Subject: Transmittal of Revision 1 to Service Bulletin Number V2500-NAC-71-0142

NACELLE - POWERPLANT - RIGHT FAN COWL DOOR - INTRODUCTION OF A DRAIN HOLE

July 15, 1997 Revision 1 - January 15, 1998 V2500-NAC-71-0142

Location of Drain Hole In Right Fan Cowl Door Figure 1

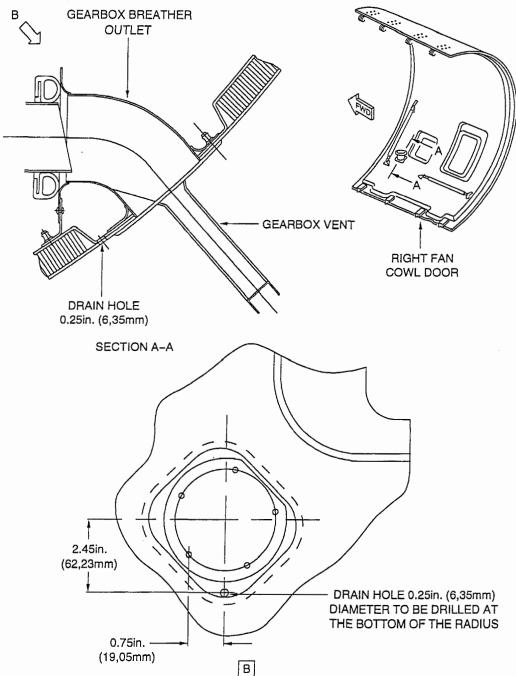
- (1) The change introduced by this Service Bulletin is as follows:
 - (a) A 0.25 inch (6.35 mm) diameter hole is drilled in the right hand fan cowl door near the gearbox breather outlet duct.

- (1) Drill a 0.098 inch (2.50 mm) diameter hole into the right Fan Cowl Door where shown. Drill from the inner face of the fan cowl door. Refer to Figure 1.

- (2) Increase the hole size to 0.25 inch (6.35 mm) diameter. Remove any burrs from the hole.
 - WARNING: SOLVENT (COMAT 01-438) IS CLASSIFIED AS A HAZARDOUS MATERIAL WHICH MAY CAUSE INJURY OR ILLNESS IF NOT PROPERLY USED. THIS PRODUCT SHOULD BE USED ONLY IN ACCORDANCE WITH THE MANUFACTURER'S SPECIFIC SAFETY AND HEALTH RECOMMENDATIONS. PRIOR TO USE OF THIS PRODUCT, CAREFULLY READ THE APPLICABLE "MATERIAL SAFETY DATA SHEET" AND FOLLOW ALL LISTED SAFETY AND HEALTH PRECAUTIONS.
